SR-2 – ADVISORY STAFF REPORT (06-05-2026)

ADDRESS: 4254 TYLER

APPLICATION NUMBER: HDC2026-00252

SCOPE: REHABILITATE DWELLING (SOME WORK COMPLETED WITHOUT APPROVAL),
REPLACE WOOD WINDOWS WITH VINYL WINDOWS

Staff photo, 05-26-2026, showing existing conditions

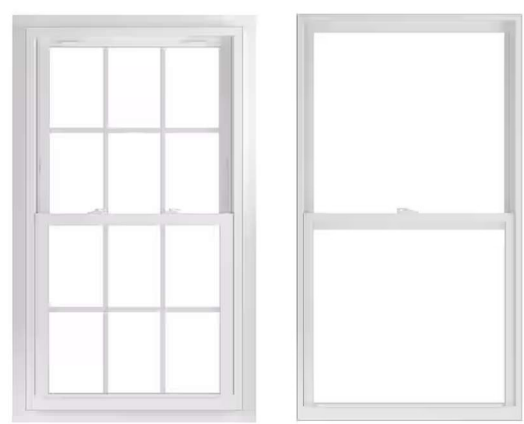
- The applicant stated that “The existing historic wood windows at the property are currently in deteriorated condition due to prolonged exposure, deferred maintenance, and water intrusion. Several windows show signs of rot, damaged glazing, broken panes, failing sash components, and deterioration of surrounding trim and framing materials.”

- The Elements of Design (Sec. 21-2-168) mention “wood is almost universally used for window frames and other functional trim.” And “windows are commonly either metal casements or wooden sash.” In this case, the wood windows provide important character that contributes to the building’s historic appearance.
- The wood windows are distinctive, character-defining historic features that mostly have not proven to be beyond feasible repair.
- Some of the conditions described, such as damaged glazing and broken panes, will impair their operation, but are reasonably repairable.

PROPOSED

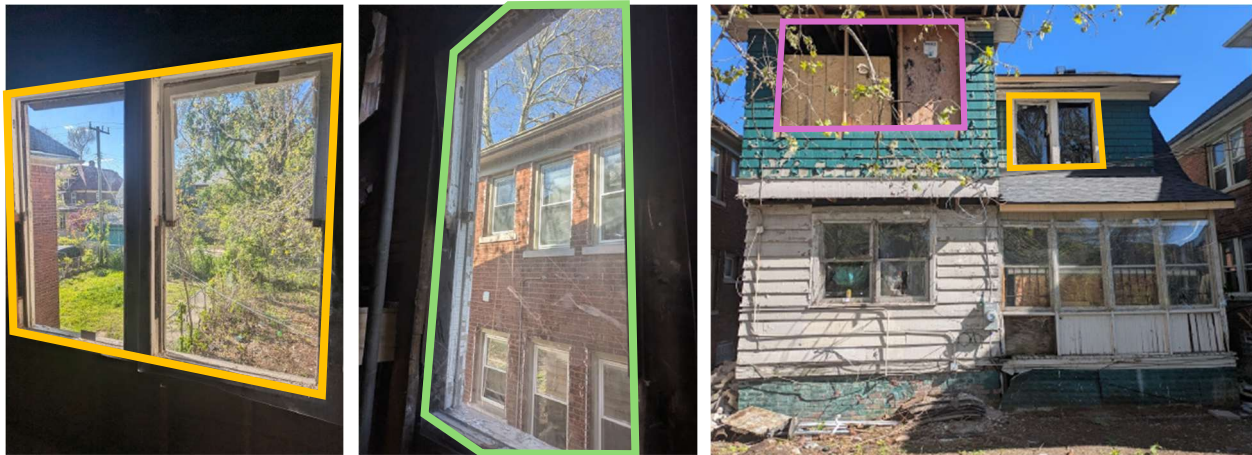
- Even if the historic window repair is found infeasible, the installation of the vinyl windows does not follow the [Historic District Commission’s ‘Historic Wood Window Guidelines’](#) or the [NPS ‘Replacement Windows that Meet the Standards.’](#) As stated in the NPS’ guidelines for replacement windows, “When historic windows exist, they should be repaired when possible. When they are too deteriorated to repair, selection of the replacement windows must be guided by Standard 6. Design, visual qualities, and materials are specific criteria provided by the Standard that are pertinent to evaluating the match of a replacement window. Evaluating the adequacy of the match of the replacement window involves the consideration of multiple issues.” Specifically, referencing the factors to consider in evaluating the match of a window:

- ***Glass size and divisions.*** *Muntins reproduced as simulated divided lights – consisting of a three-dimensional exterior grid, between-the-glass spacers, and an interior grid – may provide an adequate match when the dimensions and profile of the exterior grid are equivalent to the historic muntin and the grid is permanently affixed tight to the glass.*

- *While it may be theoretically possible to match all the significant characteristics of a historic window in a substitute material, in actuality, finish, profiles, dimensions and details are all affected by a change in material.*
- *Secondary window elements that do not match the finish or color of the window can also diminish the match. Examples include white vinyl tracks on dark-painted wood windows.*

1. The historic wood windows are distinctive, character-defining features that were not proven to be beyond repair.
2. The proposed windows do not match the old in design, texture, materials, and other visual qualities.
3. Due to their plasticity, flatness, detracting color/sheen, component profiles, and poor material quality, consumer-grade vinyl windows are incompatible with the building's overall historic character and do not exhibit an appearance consistent with the general characteristics of a historic window of the same type and period, as required by National Park Service Guidance.
